Re: Intersection Improvements at Weed Road and Shelburne Falls Road

On October 17, 2012 I visited the Weed Road intersection with Shelburne Falls Road and met with Steve Rowell for the purpose of evaluating the access improvements with the Town of Hinesburg standards. A list of my observations and comments are summarized below.

Weed Rd

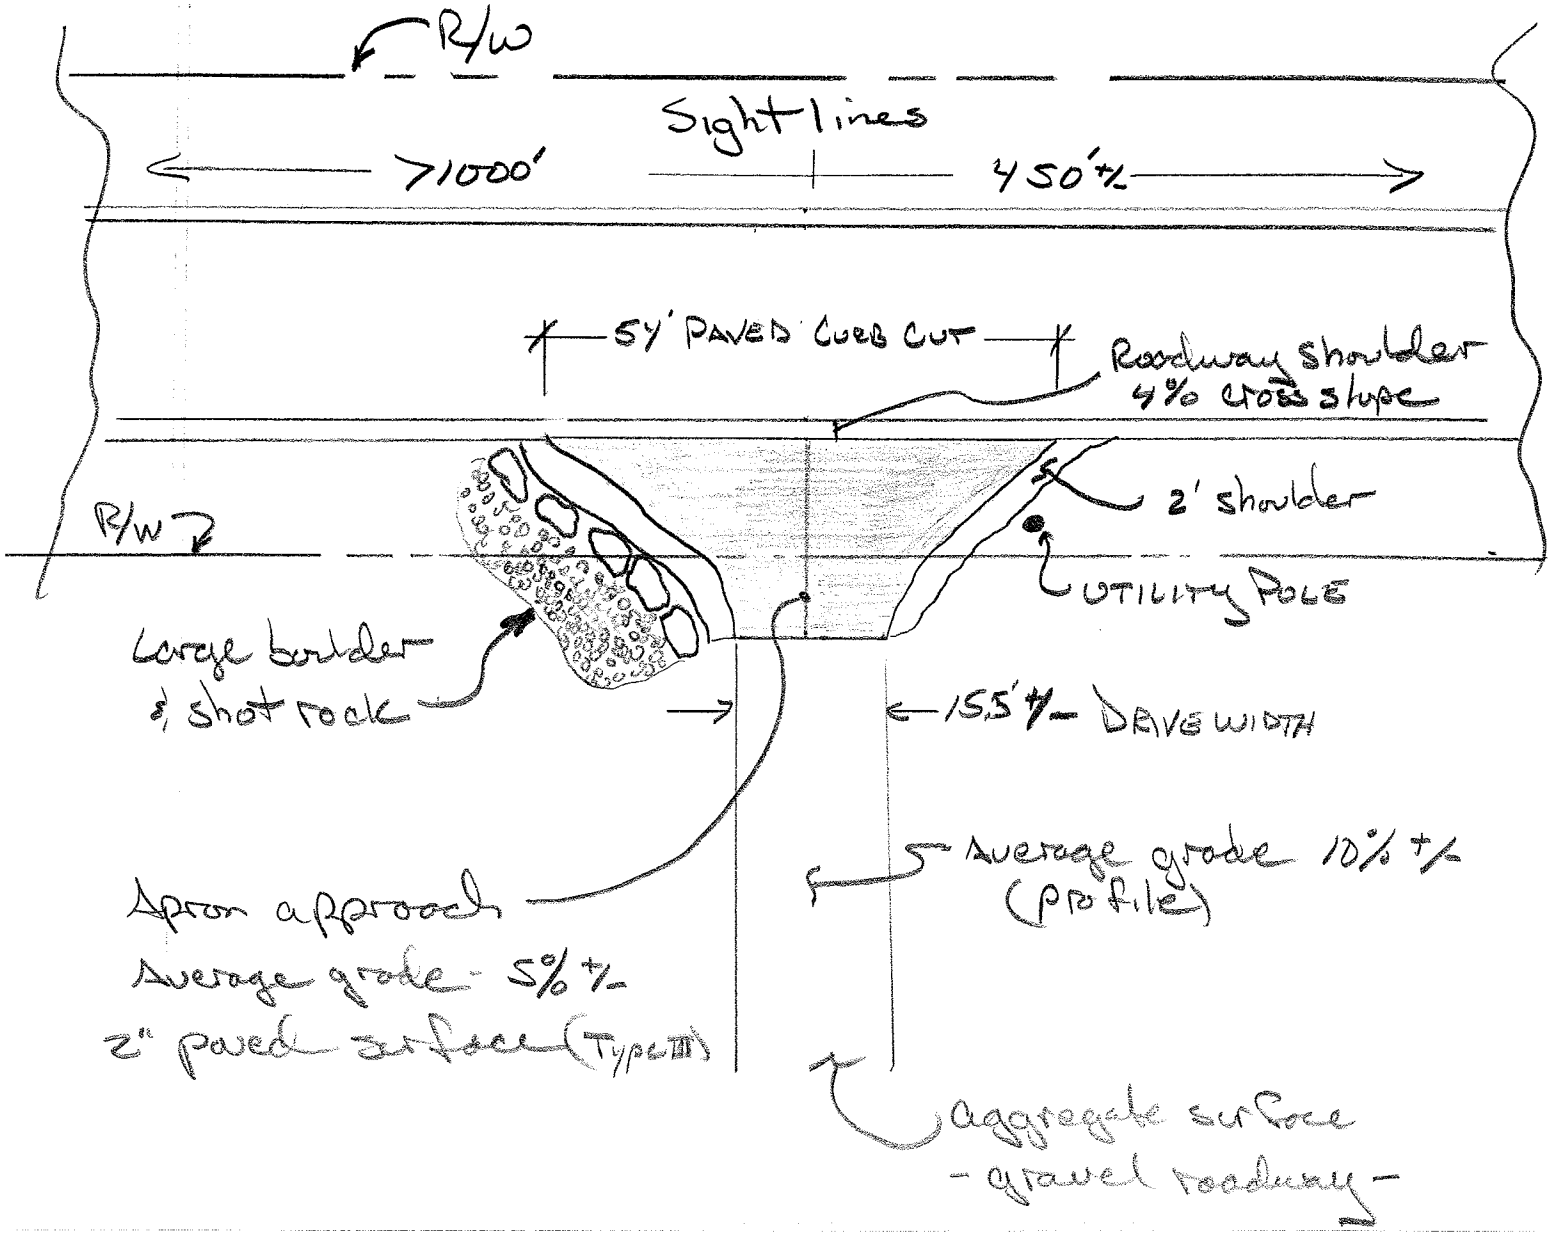
There are 4 pollouts
for passing
